工程指示 / 要求簡箋(E.I.)

工程指示編號：EI / 2504 / 20

工程名稱：亞皆老街中電

工程項目：鋁飾線 繪畫模圖 (1 個) X85921

X85921

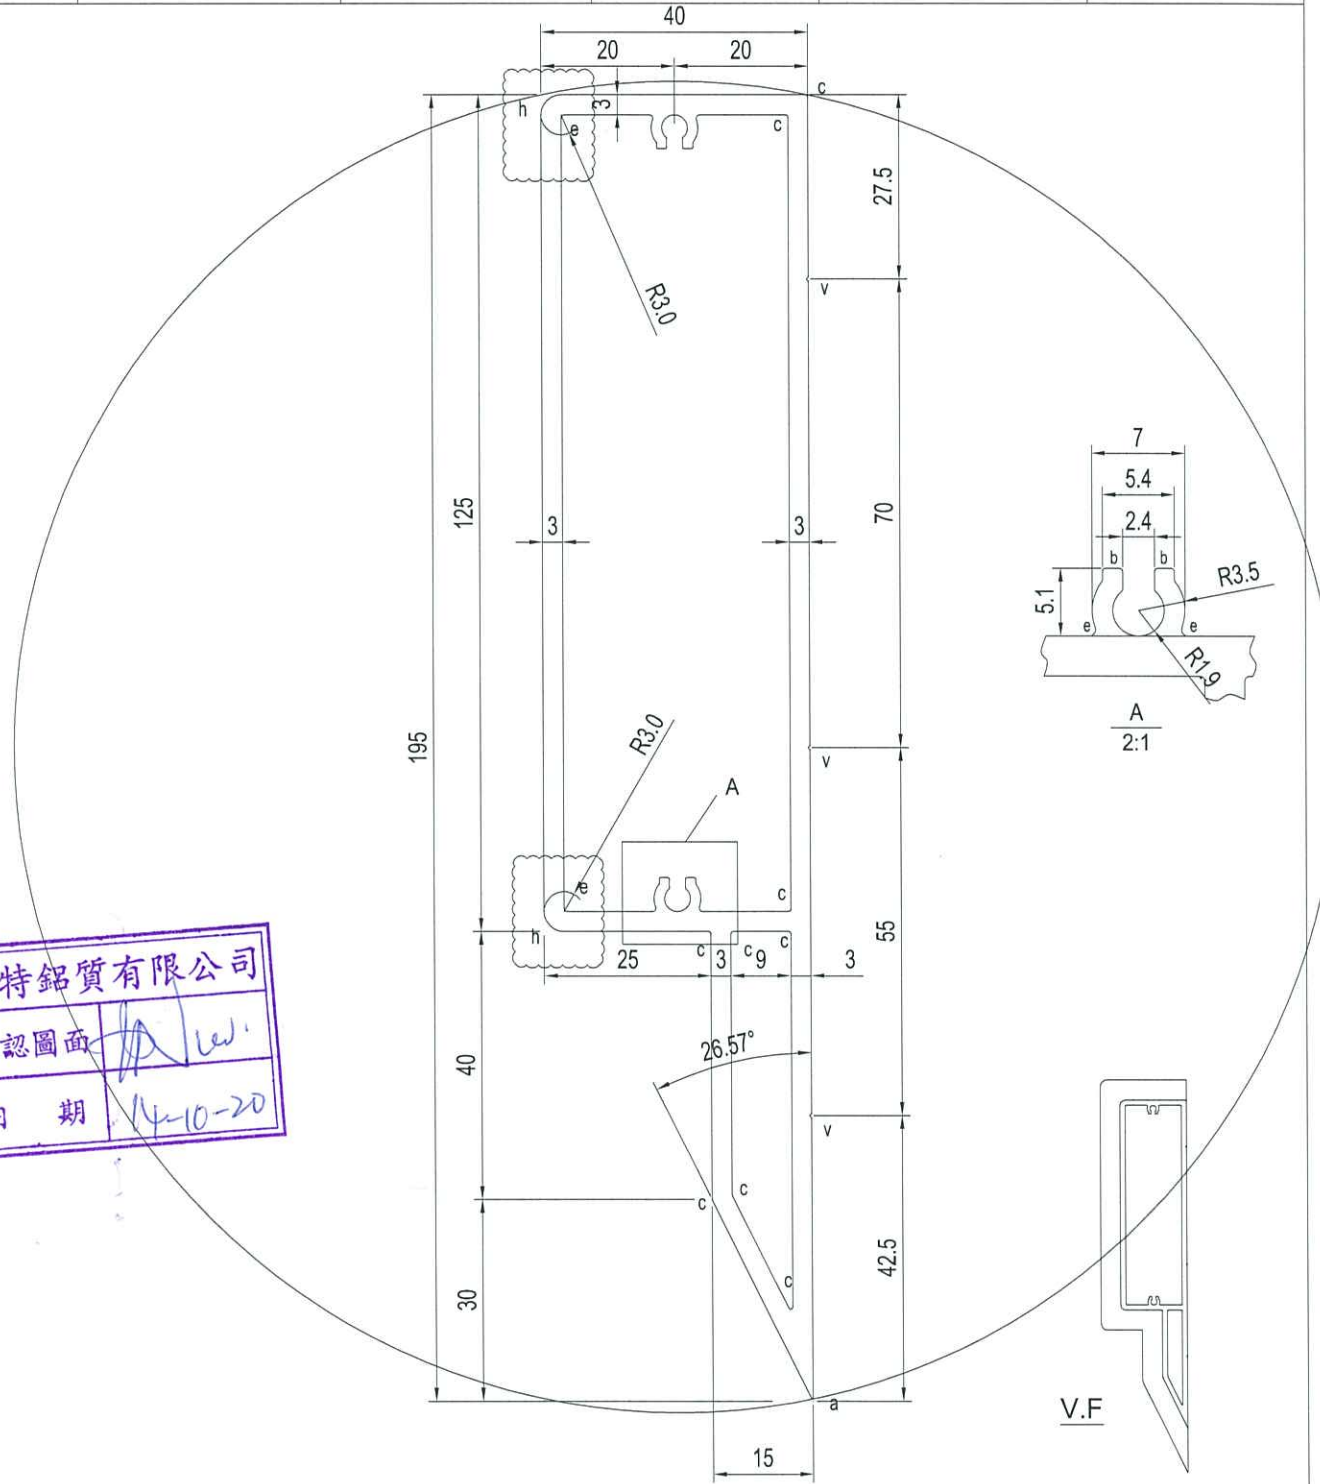
請按加工圖繪畫修改模圖給鋁飾線鋁模用。

因此模為外牆鋁板用，需要和上下層鋁板追線，要補回 R 位才可。 (R3)
